ADDENDUM NO. 1
TO
MILLER ROAD INTERSECTION & CURVE RECONSTRUCTION PROJECT
PHASE 1 STP-5403(680) & PHASE 3 STP-5403(681)
COUNTY OF JEFFERSON, MISSOURI

August 11th, 2021

CDG PROJECT NO.
18101
DRAWING NO.
C-412

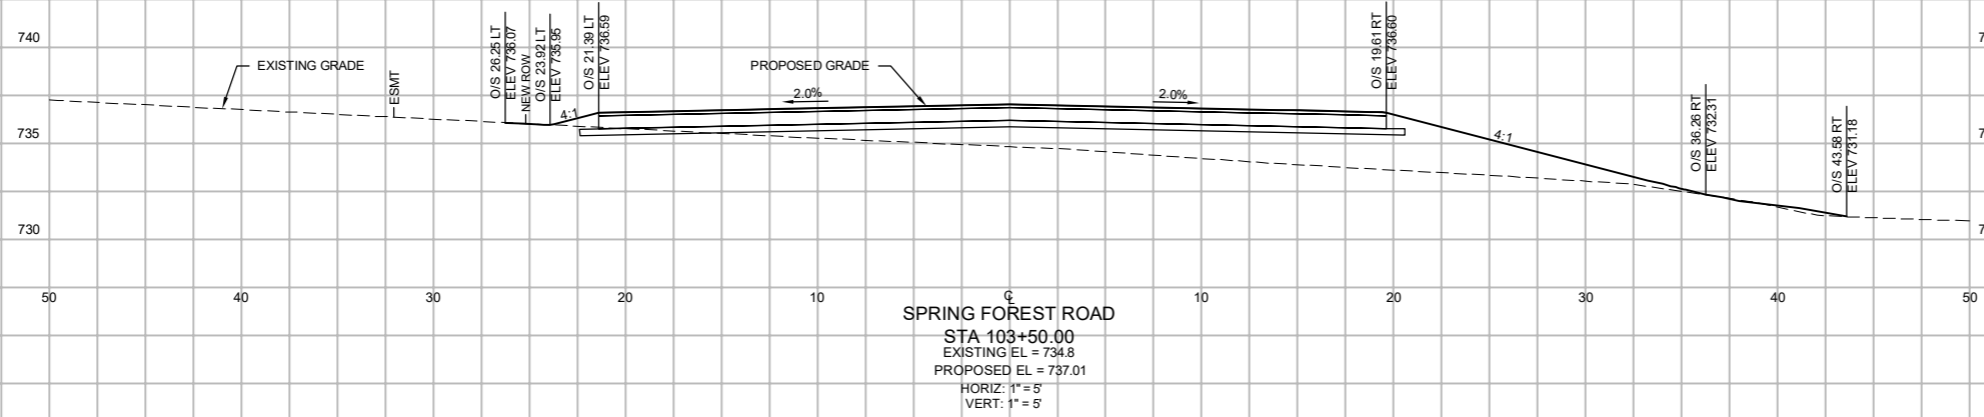
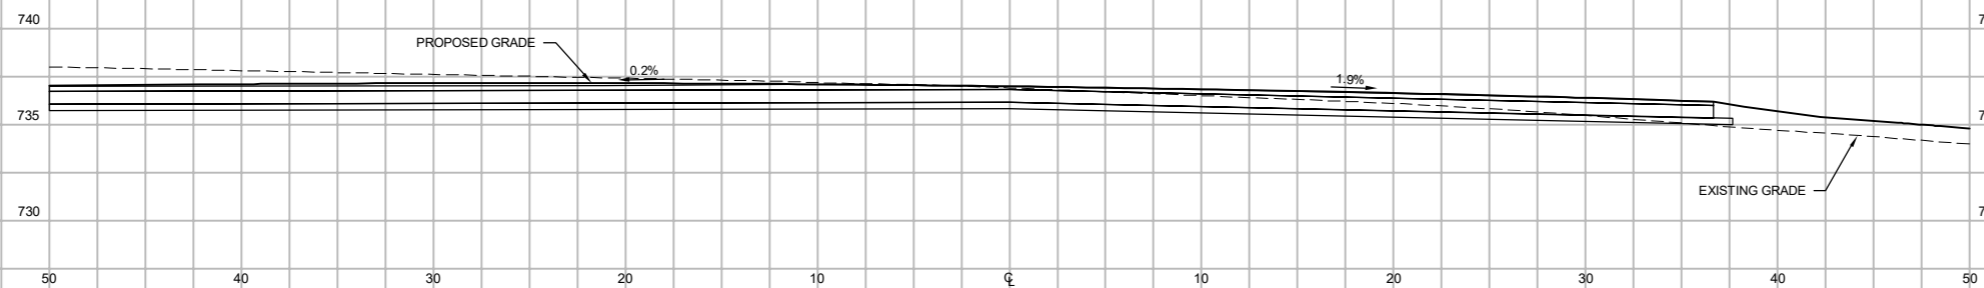
Remove plan sheet C-412 and replace with plans sheet C-412, revised 8/11/21 - 21 – Bid Addendum #1. Reason: the revised plans have shown the revised cross-sectional area at STA 103+00 and STA 102+50 showing the slope face protection system.

CDG PROJECT NO.
 18101
 DRAWING NO.
 C-413

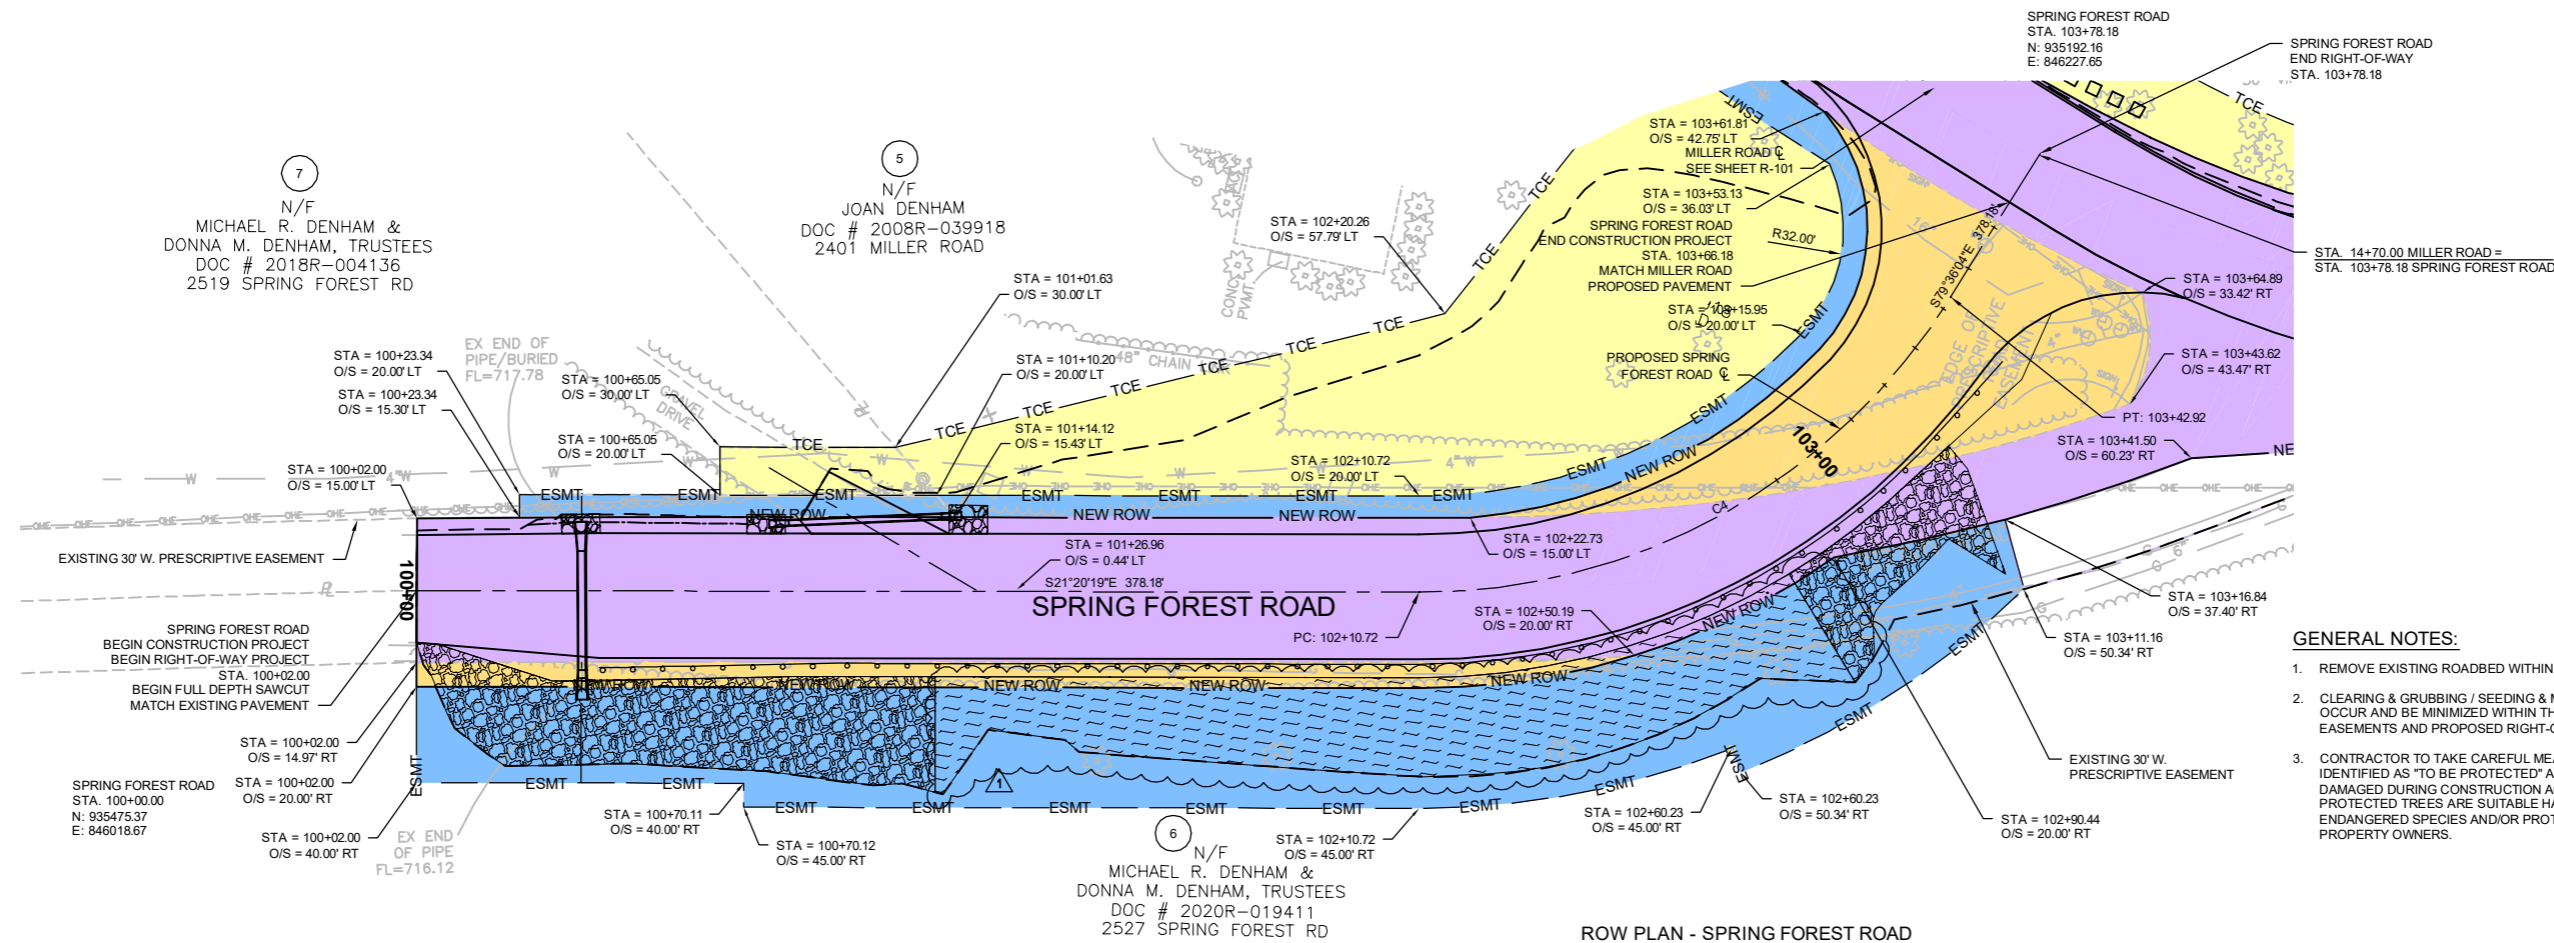
Remove plan sheet C-413 and replace with plans sheet C-413, revised 8/11/21 - 21 – Bid Addendum #1. Reason: the revised plans have shown the revised cross-sectional area at STA 103+50.
